Planning Application Ref: **AW/149/19/T**

Location: **2 Grange Lodge, Aldwick Street, Aldwick, PO21 3AN**

Description of works: **Crown reduction up to 10m and crown thin up to 25% to 1no. beech tree**

Figure 2 Positions of final cuts

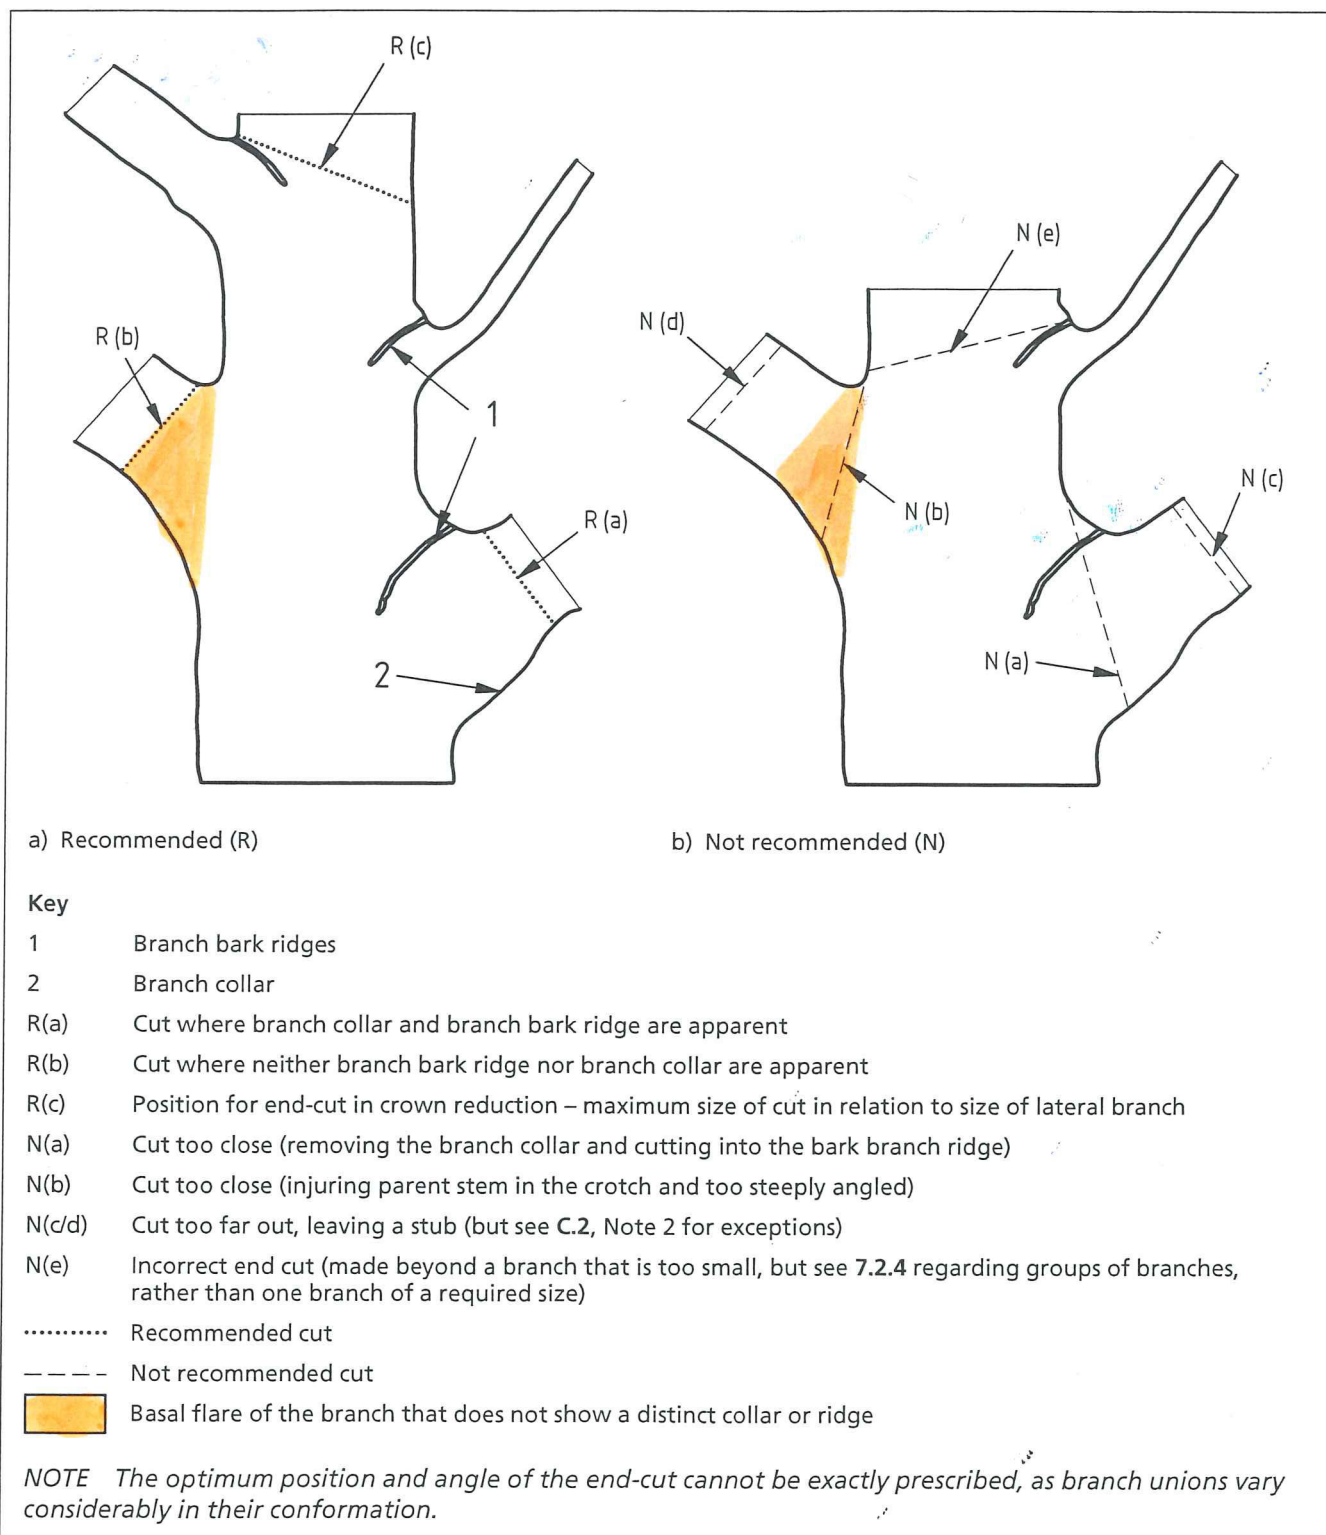
- Where whole branches are to be removed and final cuts made close to the trunk or branch union they are to be made as shown in Figure 2 of BS3998:2010
- Where branches are to be shortened back the final cuts are to be made at the correct angle shown in BS3998:2010 and adjacent to a live bud or lateral.
